**NEW MEXICO
ENVIRONMENT DEPARTMENT**

**RE: SHALLOW SATURATED ZONE GROUNDWATER
PUMP TEST WORK PLAN, AUGUST 2016
HOLLYFRONTIER NAVAJO REFINING LLC - ARTESIA REFINERY
EPA ID NO. NMD048918817
HWB-NRC-16-004**

The New Mexico Oil Conservation Division (OCD) has reviewed the "Shallow Saturated Zone Groundwater Pump Test Work Plan" dated August 2016.

**Shallow Saturated Zone Groundwater Pump Test Work Plan
HollyFrontier Navajo Refinery
Artesia, New Mexico**

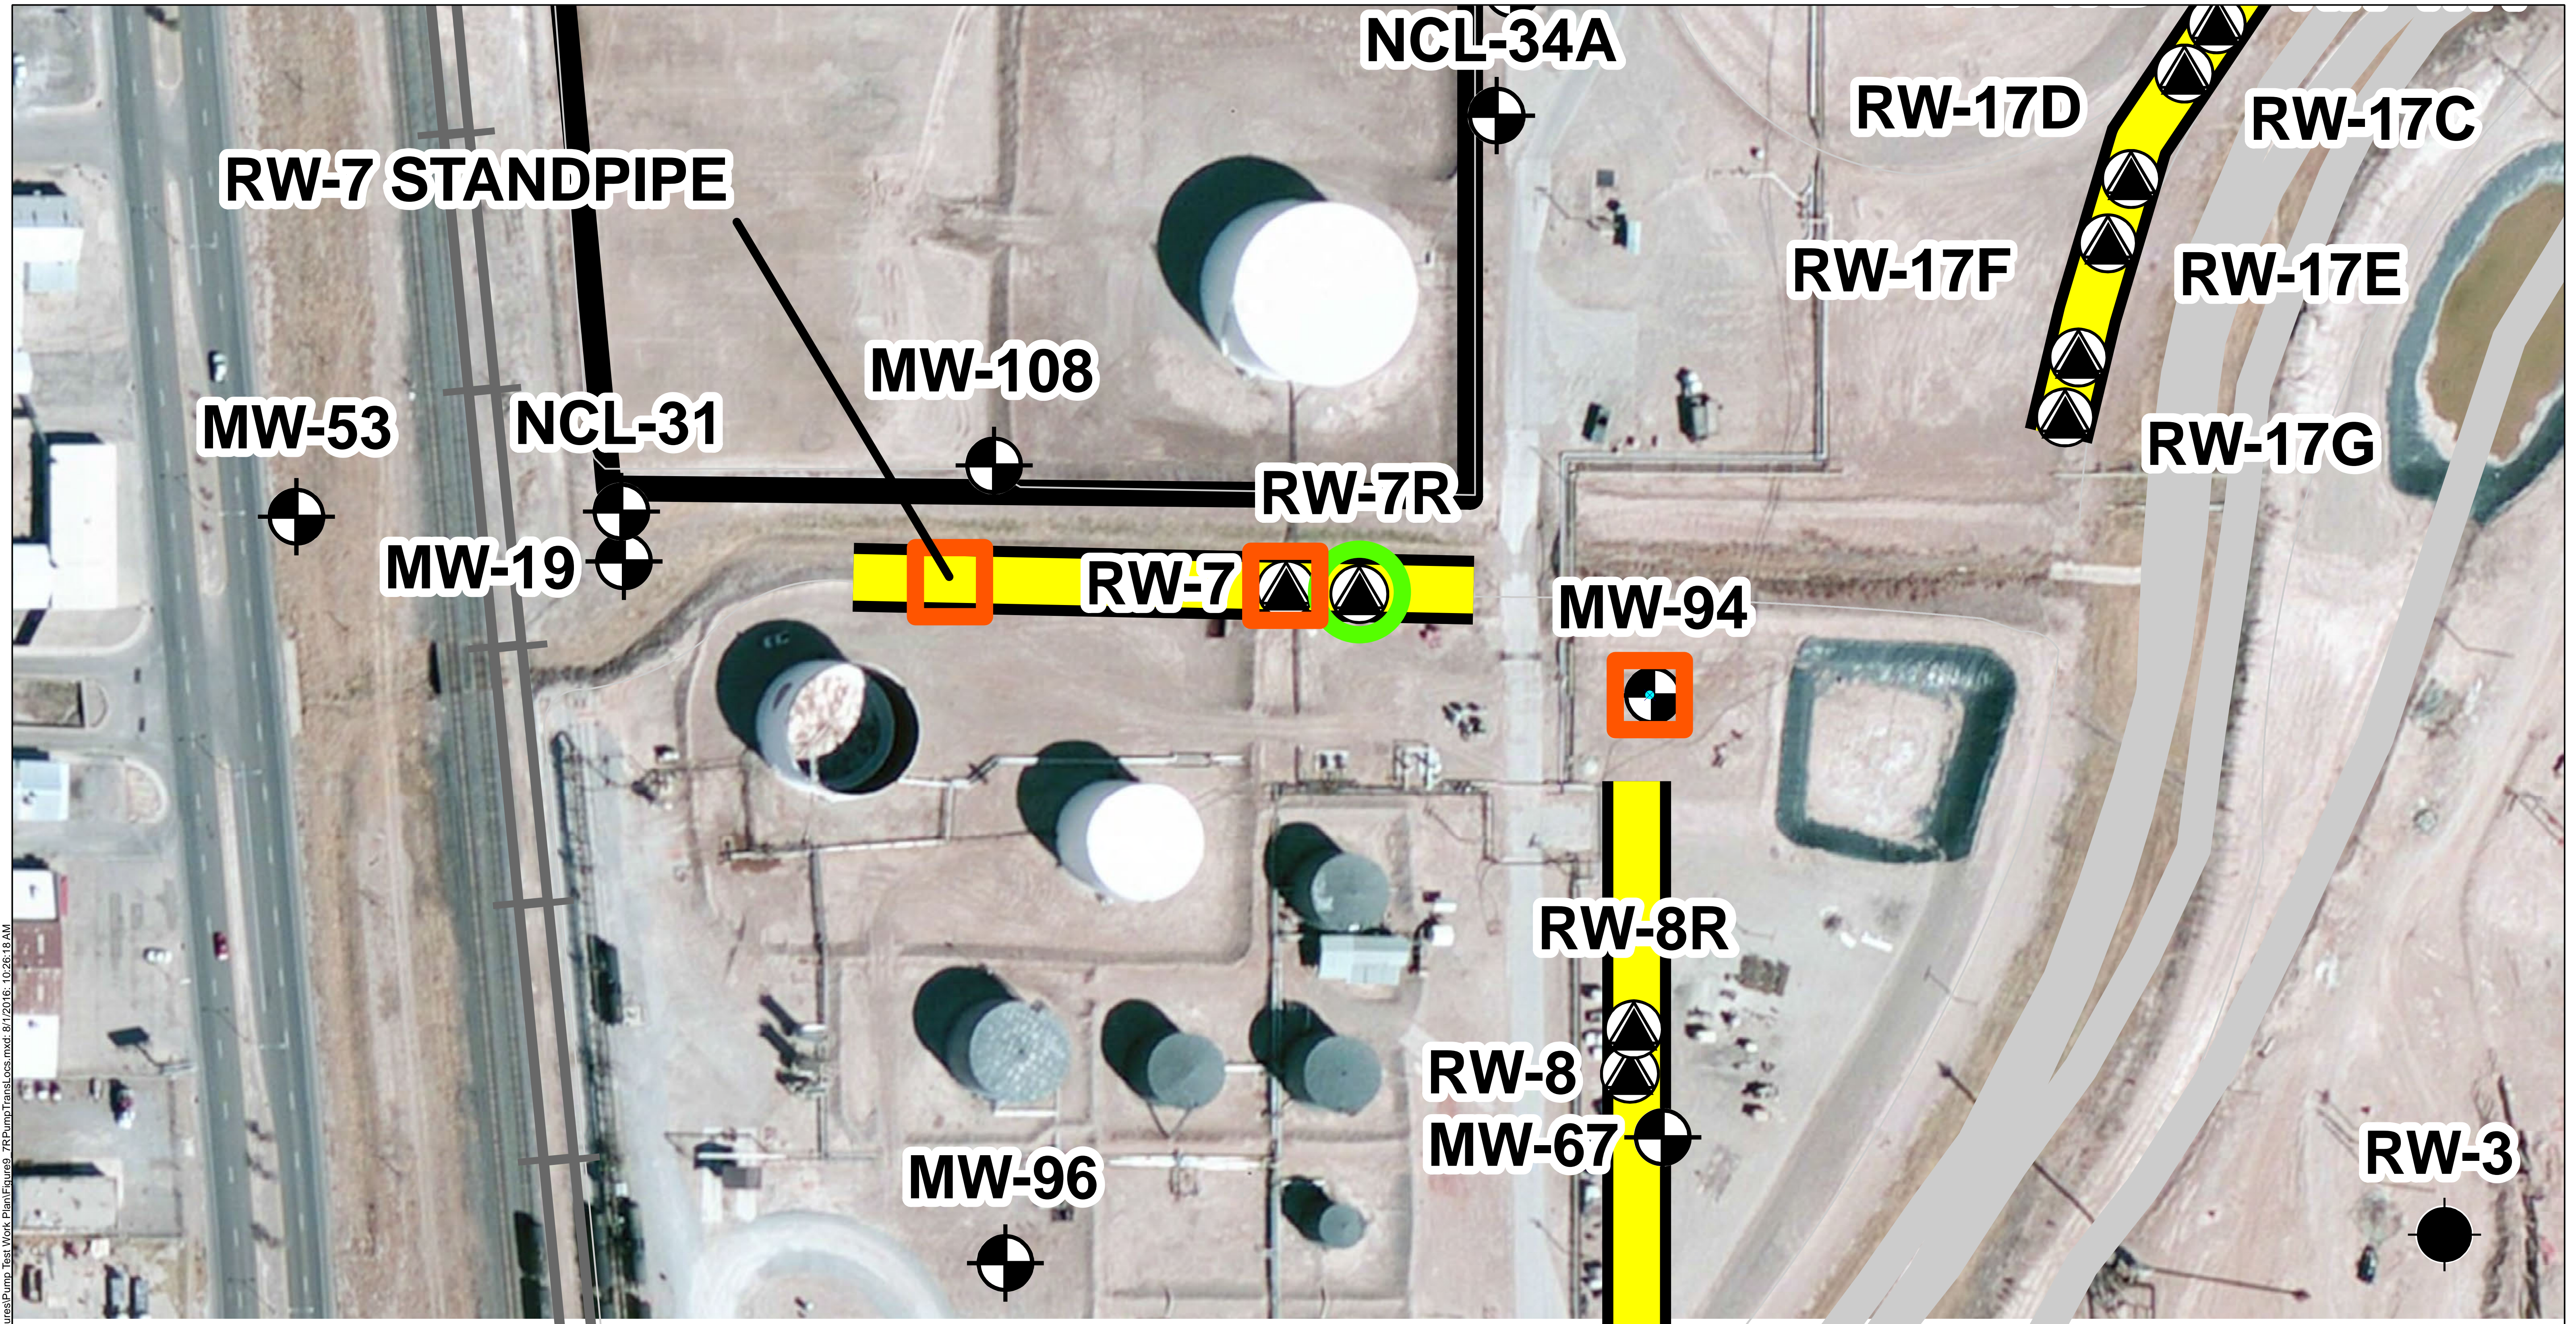
- 4) Figure 5: 2015 PSH extent in the shallow saturated zone is likely influenced by a higher water table level.
- 5) OCD expects that HollyFrontier will assess groundwater recovery locations for optimum capture of contaminants with the potential to migrate off-property and pose an imminent threat to receptors, public health, and/or the environment hydrogeologically downgradient from the source(s) of groundwater contamination.
